NE Adm Services
Veteran's Home Garage Addition
APMA Project 12066
January 28, 2013

(600 East Benjamin Avenue, Norfolk, NE 68701)

This addendum is issued by the Owner to all known bidders prior to receipt of Proposal. Bidders shall acknowledge receipt of this Addendum by so indicating on the Proposal Form. All information and instruction given herein shall become a part of the Contract Documents.

V1 FLOOR PLAN

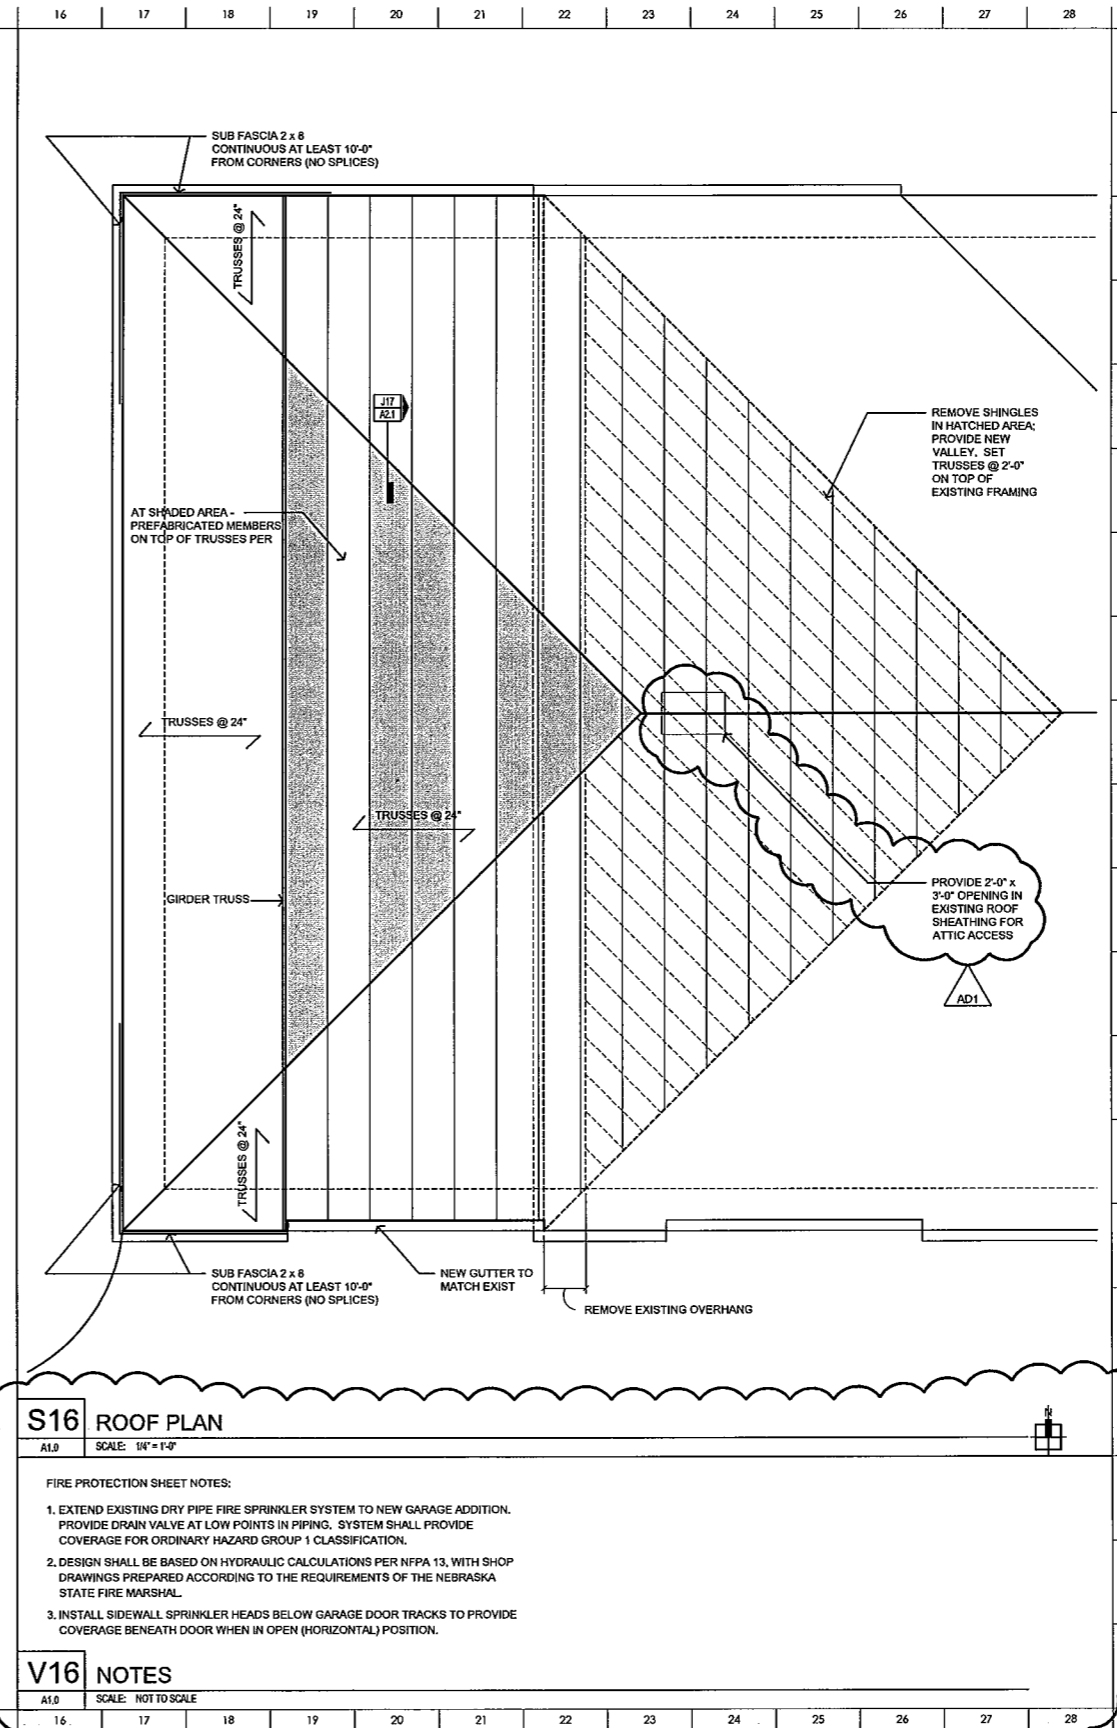
- a. Overhead door to be 12'-0" w. See Supplemental Drawing AD1.
 - Q3. Foundation reinforcing detail
 - a. See detail V1/A2.2
 - Q4. Statement concerning salvaging truss?

- a. See Supplemental Drawing AD1

- Q11. Can restrooms in maintenance shop be used by Contractors?
- a. Yes
- Q12. Access door to attic in new addition
- a. See Supplemental Drawing AD2
- Q13. Floor elevation on plan call out 105 but needs to be checked out maybe 100

- Q20. Move inside door from 2' to 4' north to correct for Electrical box in CMU
- a. See Supplemental Drawing AD1
- Q21. Top of wall detail (F17) truss should rest on wall (check out)

- a. Floor at overhead door should match existing floor elevation. See Sheet V1/A1.0.
- Q14. Architect estimate for project cost
- a. Not needed
- Q15. Add roof vents

- AD1. Revised – Sheet A1.0
- a. Move Overhead Door to east.
 - b. Move interior walkway door north 2'-0"
 - c. Overhead door to be 12'-0" wide.
 - d. All finishes to match existing.
 - e. Provide garage door opener; match existing.
- AD2. Revised – Sheet A1.0
- a. Provide 2'x3' opening in existing sheathing to access attic in addition.
- AD3. Revised – Sheet A2.0
- a. Ridge Vent to match existing.
- AD4. Revised – Sheet A2.1
- a. Truss to sit on top of wall – see revised detail F17/A2.1
 - b. Typical door jamb detail – detail D23/A2.1
 - c. Beam Bearing Detail – detail J23/A2.1
- AD5. Revised – Sheet A2.2
- a. Provide soffit vents in aluminum soffit – see revised detail V1/A2.2

A2.1

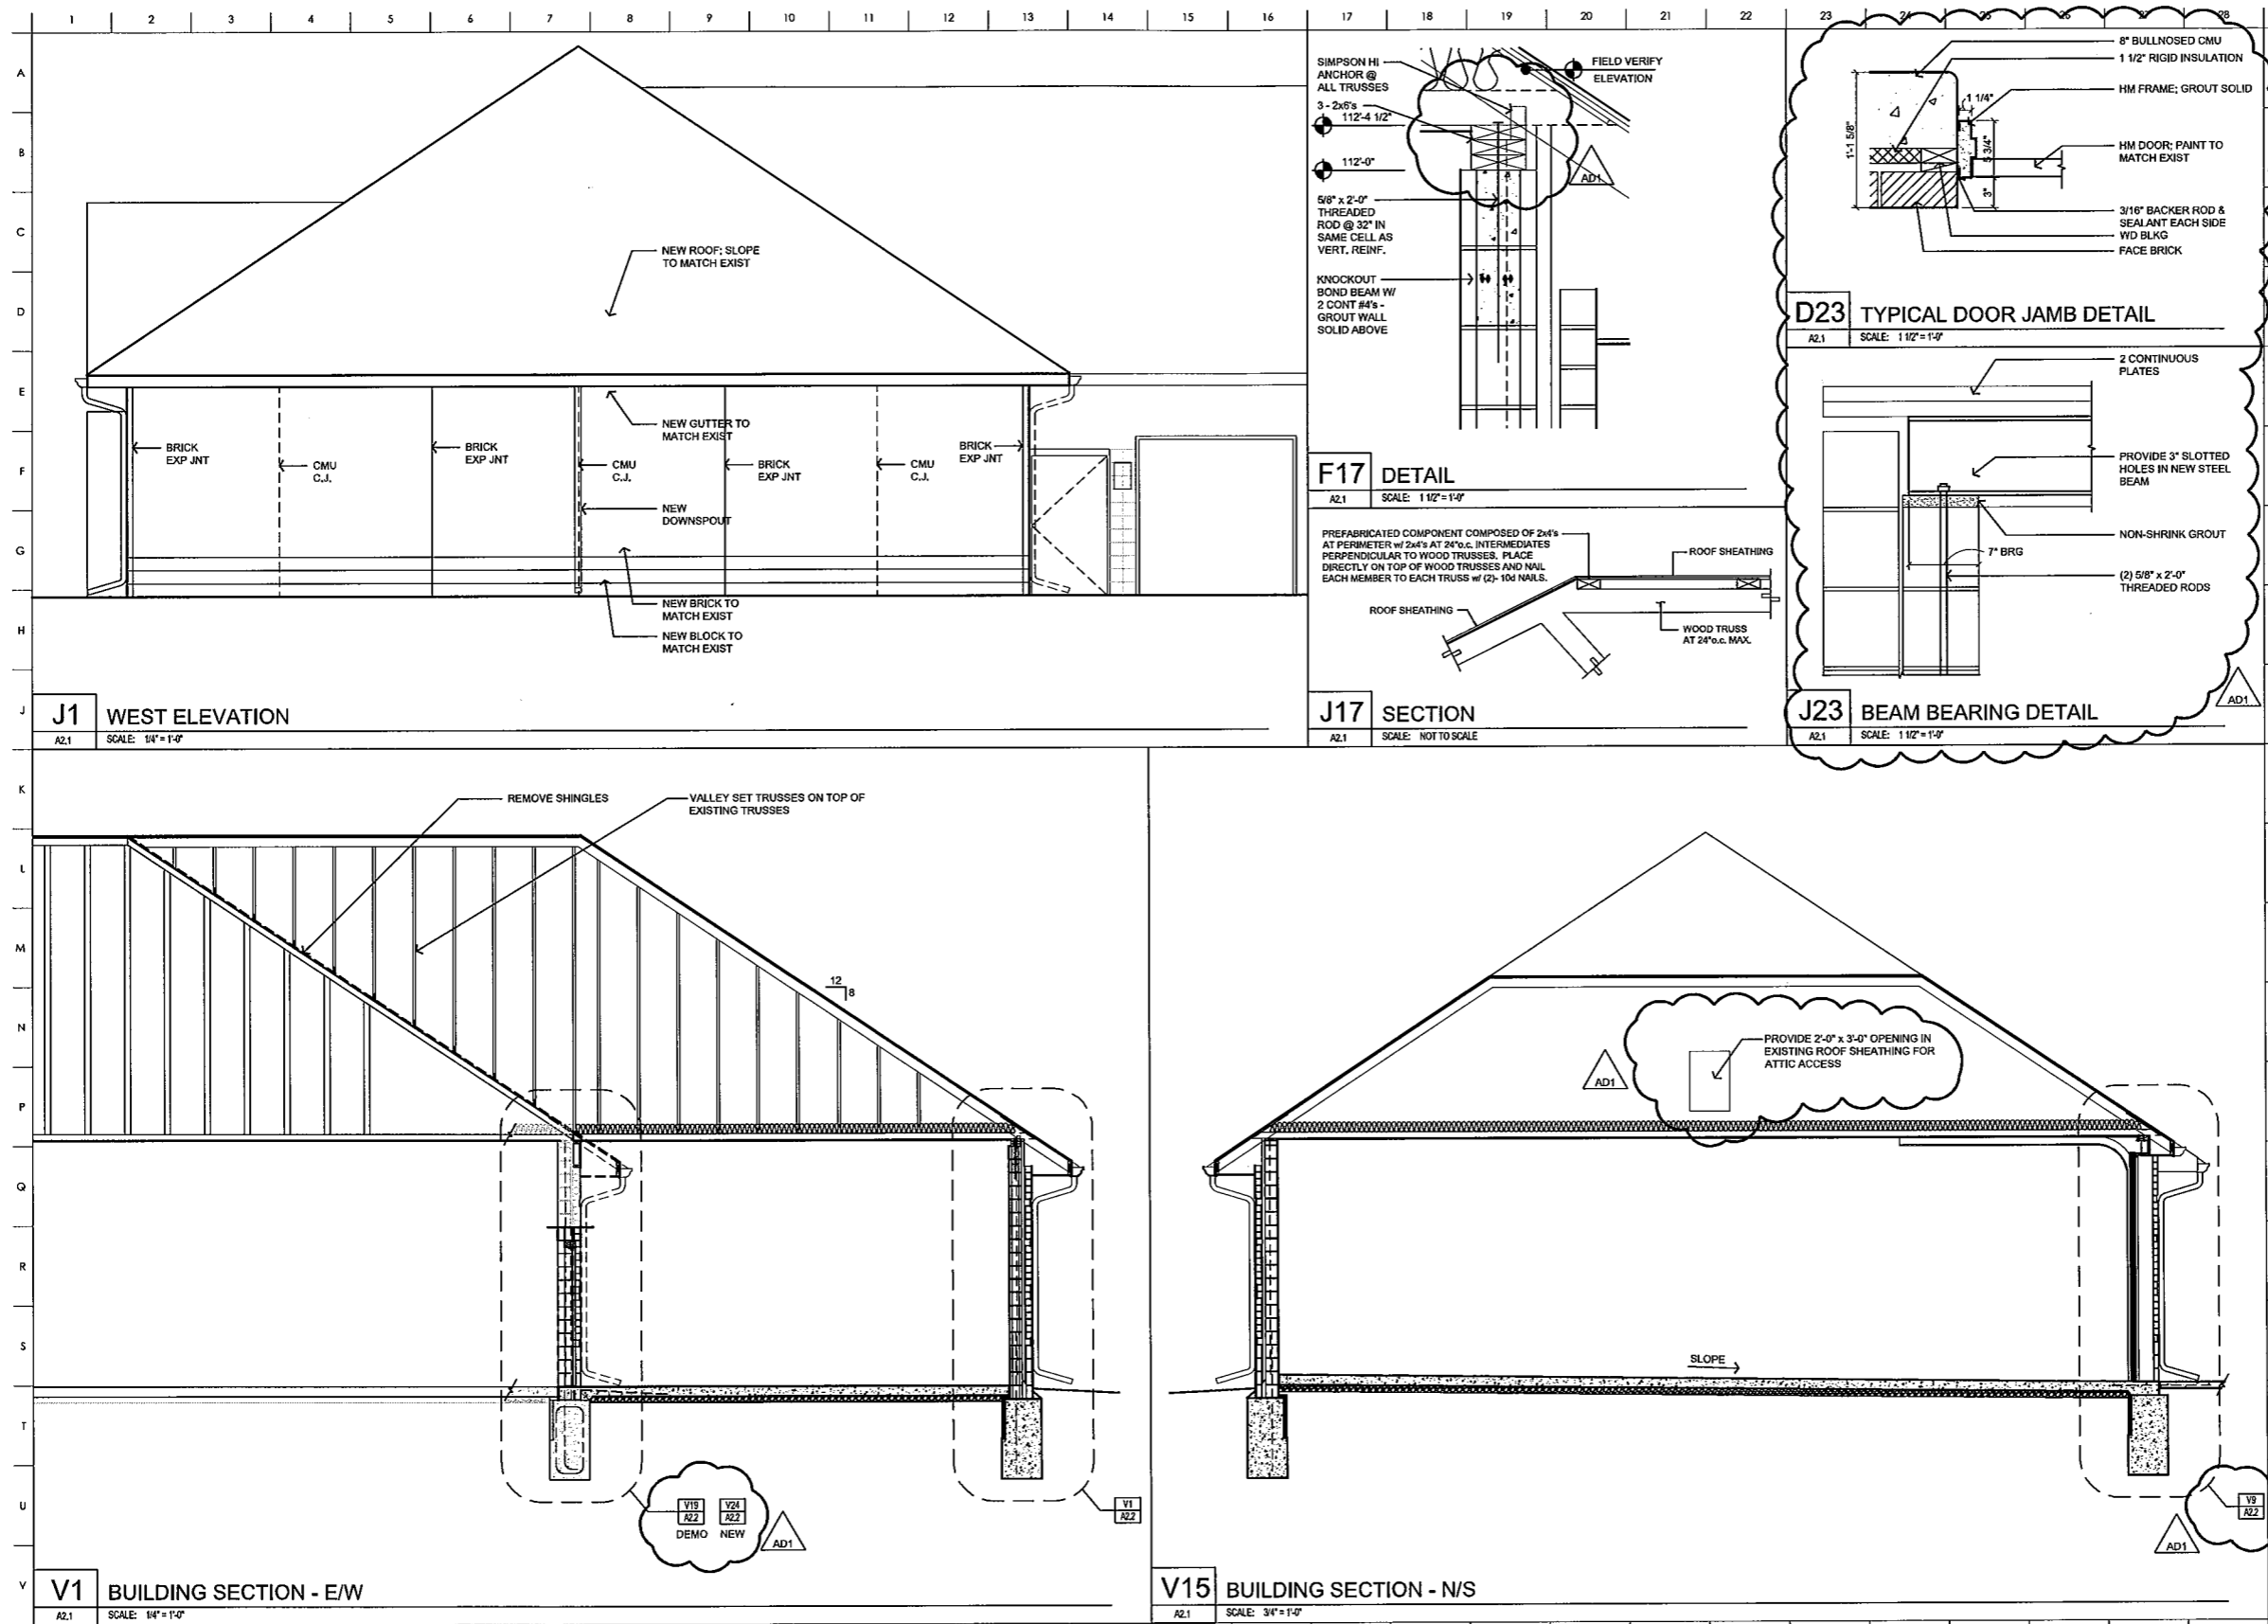
- a. See Detail V1/A2.2
- Q18. Match trim on doors like existing (paint to match)
- a. All finishes to match existing.
- Q19. Detail door jambs
- a. See Supplemental Drawing AD4 – Detail D23/A2.1

- a. See Supplemental Drawing AD4
- Q22. Should floor be sloped?
- a. Yes, See drawings V1/A1.0 and V15/A2.1
- Q23. Original plan details sheets A102, A202, A501 & footing detail 3 over 501

A2.2

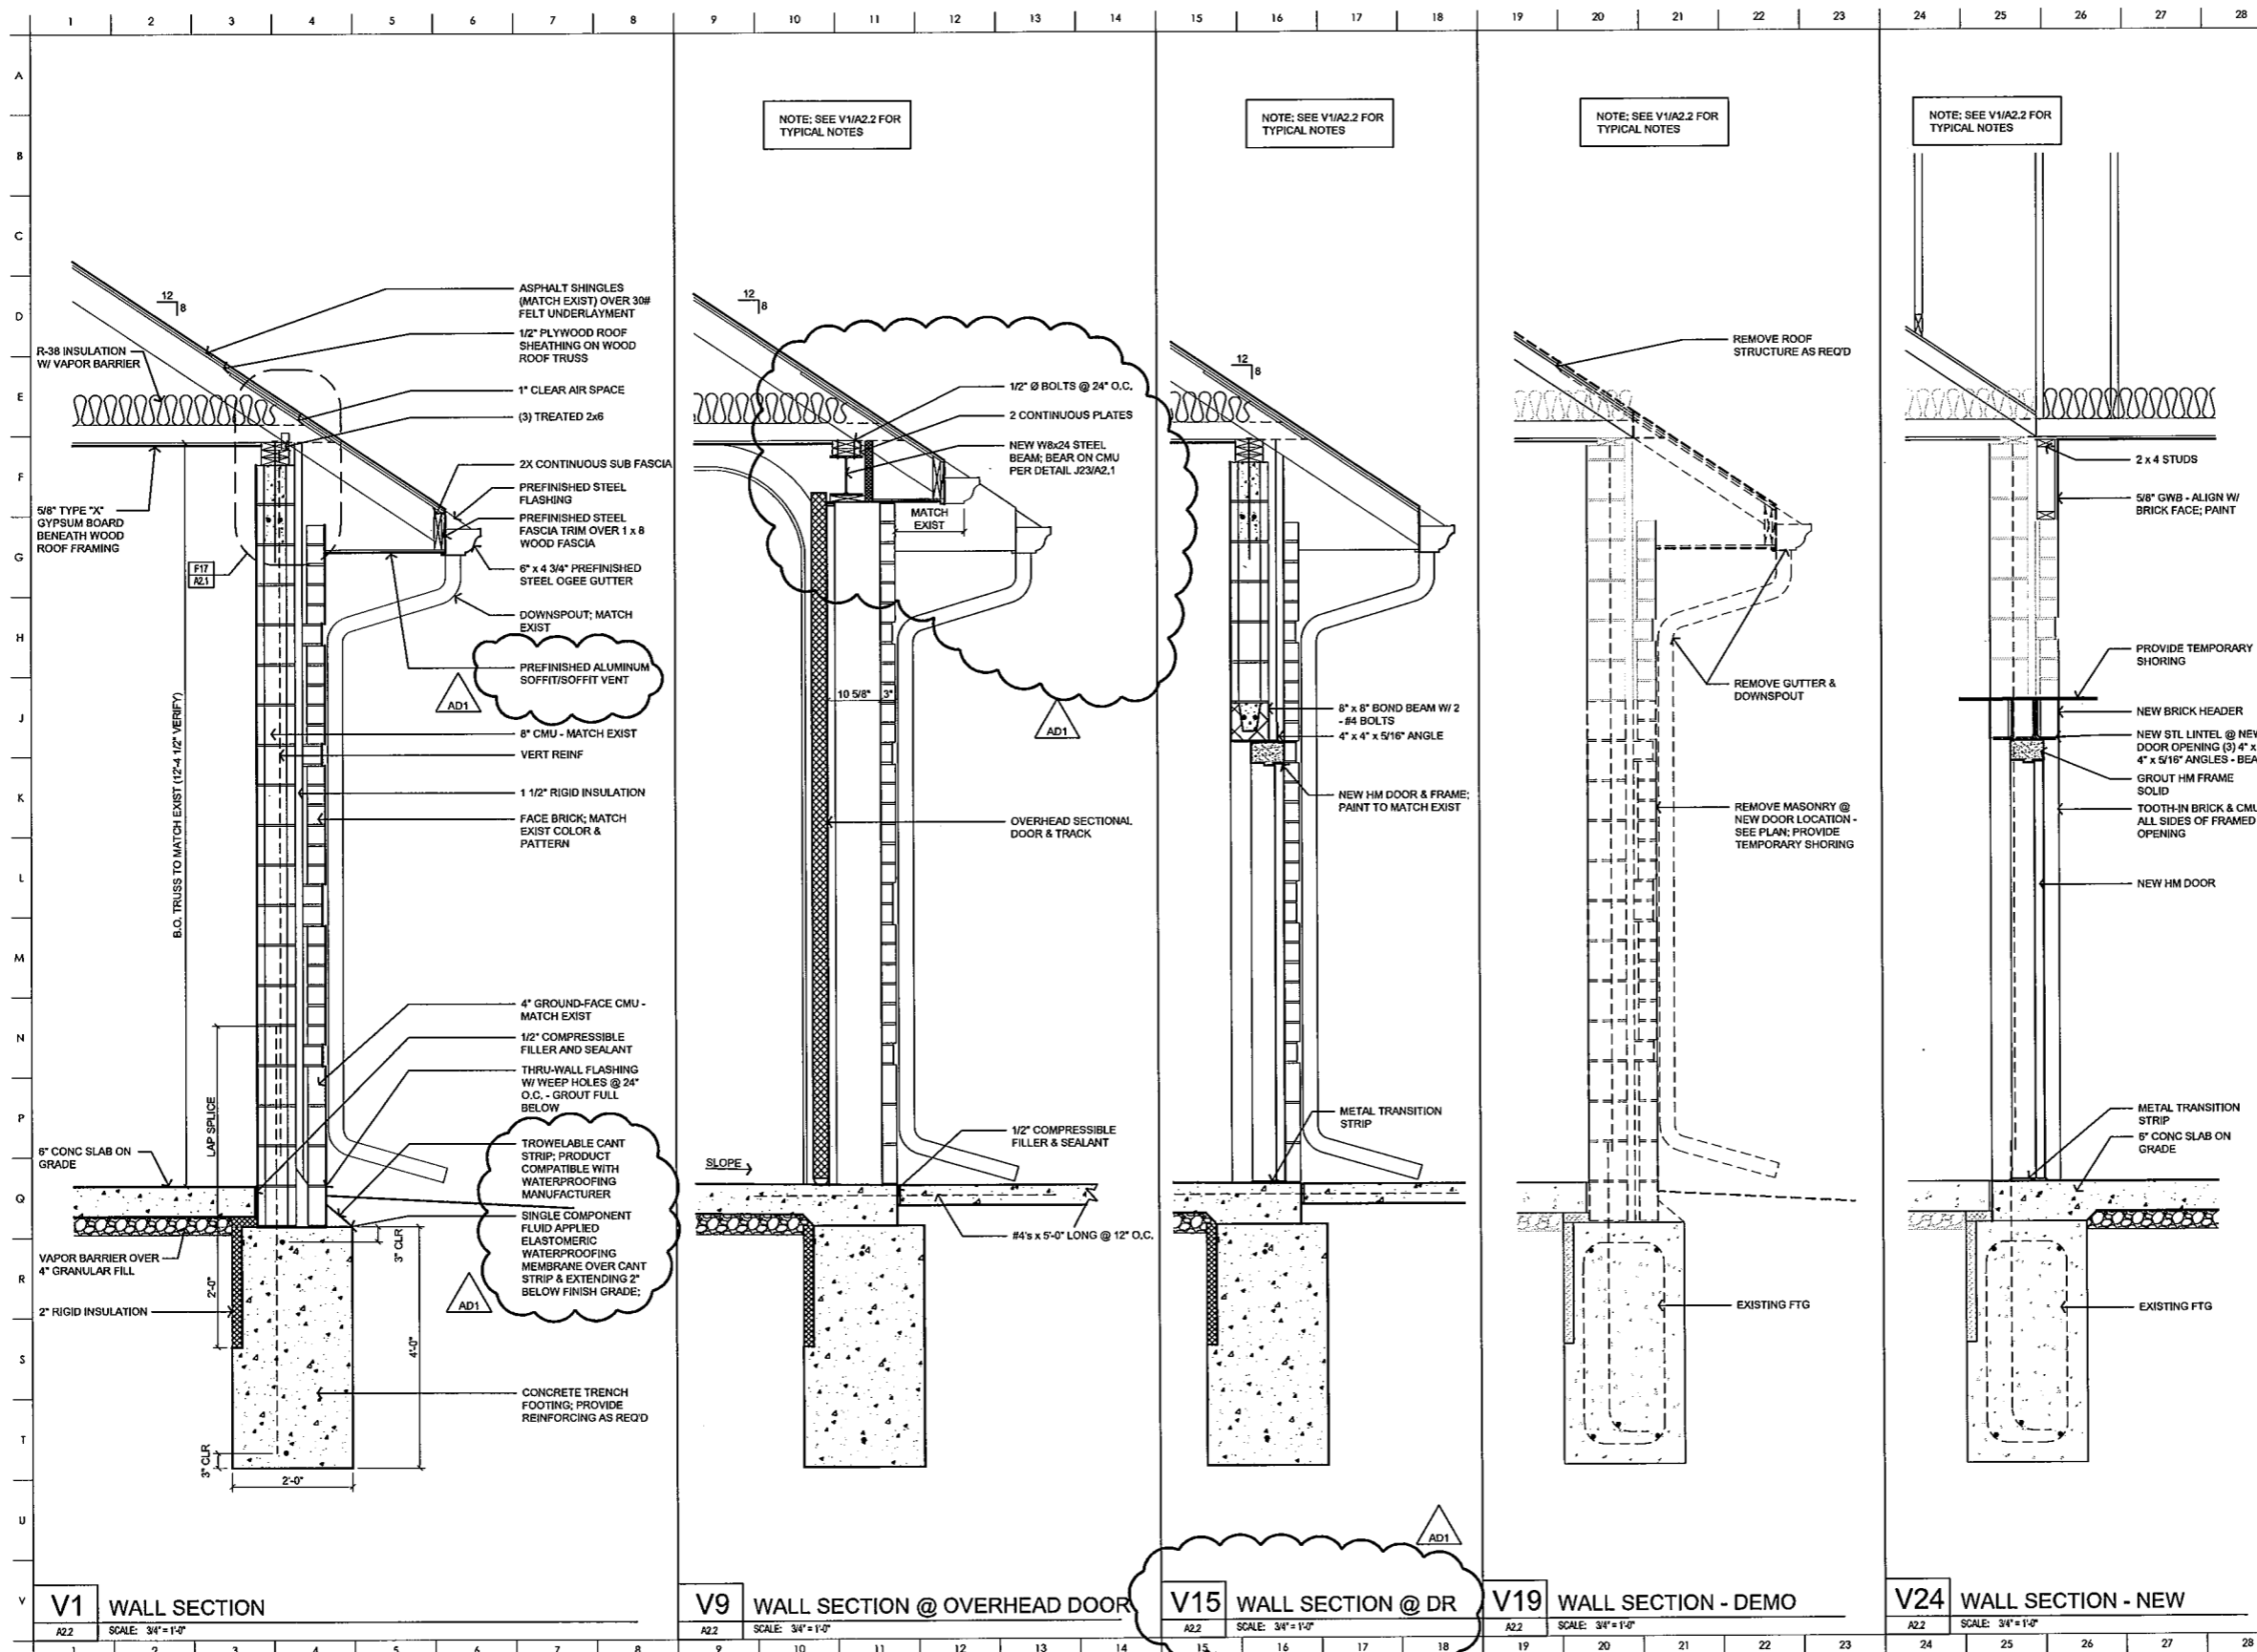
- a. Remove note to salvage truss for reuse; See detail V19/A2.2
 - Q5. Sprinkler system for attic & storage area addition
 - a. Extend dry piping in existing attic to new addition. See notes V16/A1.0
